HISTORIC LANDMARK COMMISSION  
STAFF REPORT

TRACY AVIARY  
AMAZON ADVENTURE EXHIBIT  
New Construction & PLNHLC2008-00991  
Liberty Park, 589 East 1300 South  
January 7, 2009

***Request***

## Site Plan and Elevation Drawings

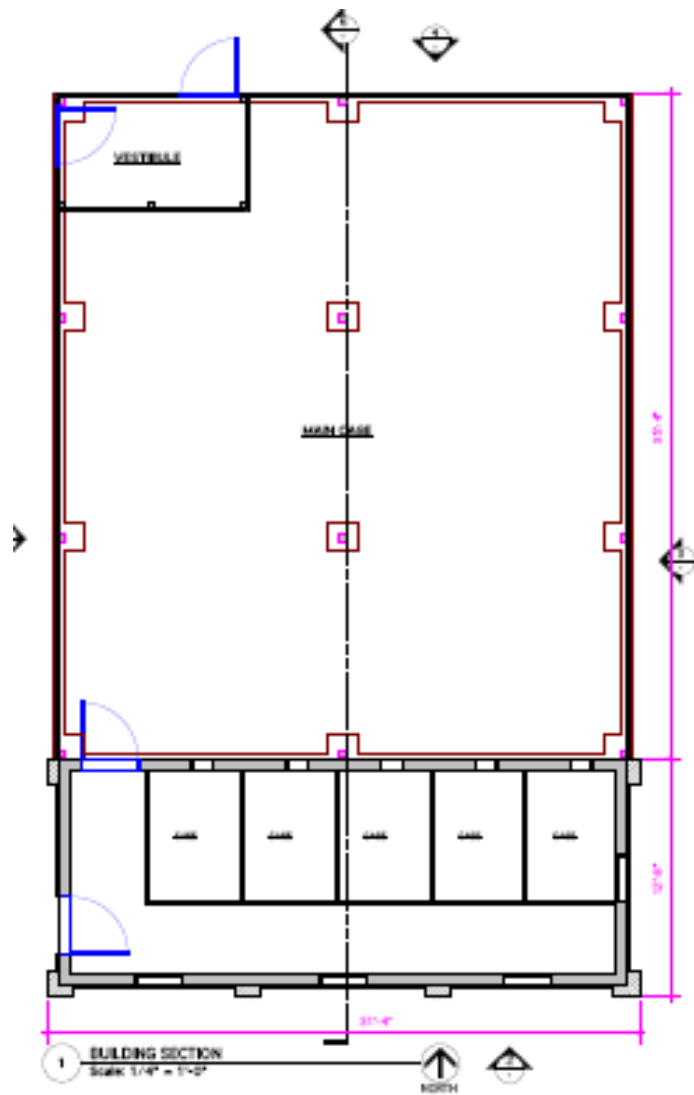
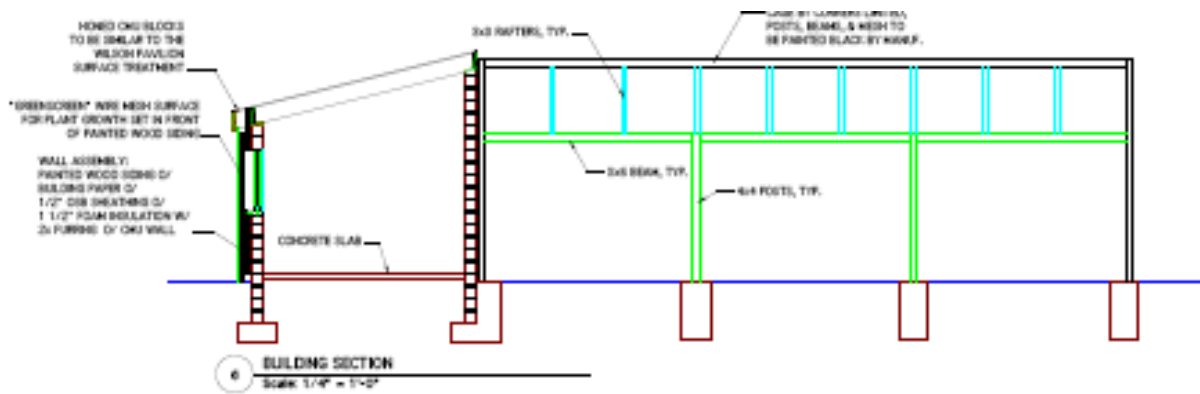
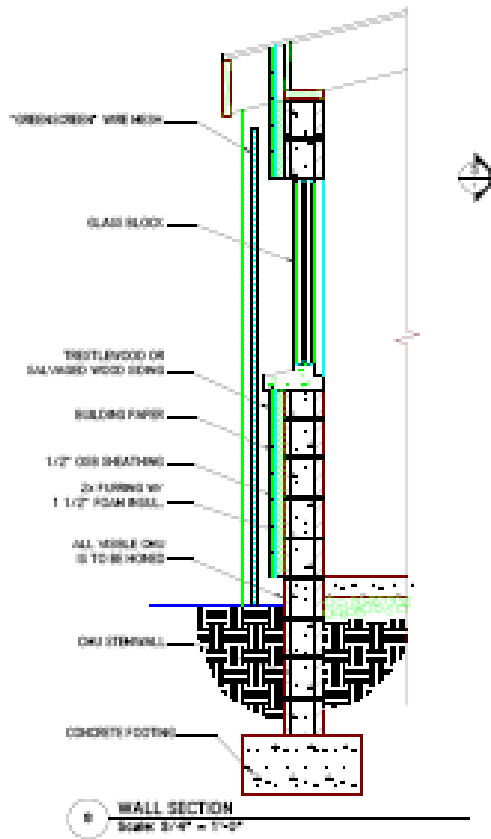
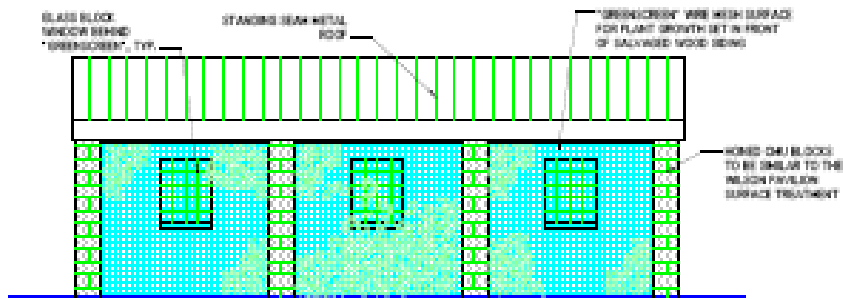
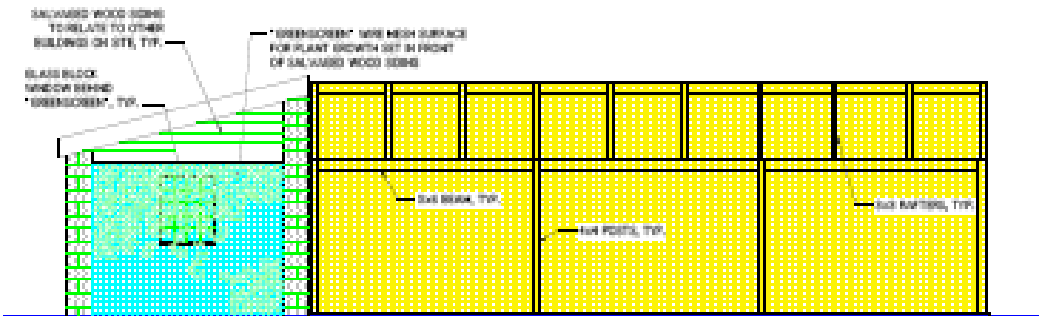
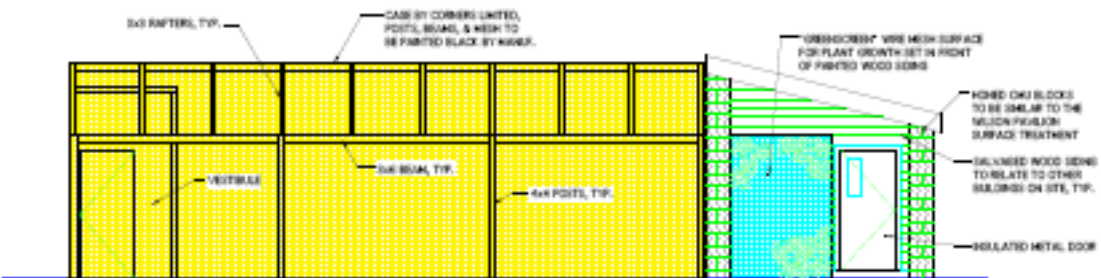
**Finding:** The scale and form of historic structures within the park vary greatly depending on their function. The proposed structure will be among the smaller scaled buildings in the park. In terms of height, width, and square footage it will be similar in scale to nearby structures, and smaller in scale than some historic structures of the park and similar to a comparable interactive exhibit on the opposite end of the Aviary. The building is compatible in scale and massing and so meets this standard.

**Finding:** The proportions of openings and rhythm of solids to voids in the façade is compatible with existing structures, including the Chase Mill located nearby. The proposed building does not have a porch; however none of the exhibit spaces within the Aviary have porches. The materials-- honed CMU, wood siding, metal roofing, and wire mesh--are in keeping with other buildings and exhibits in the Aviary. The glass block for the windows is a new material for the Aviary; however, these windows will be partially obscured by the mesh vegetative screen. This project substantially meets this standard.
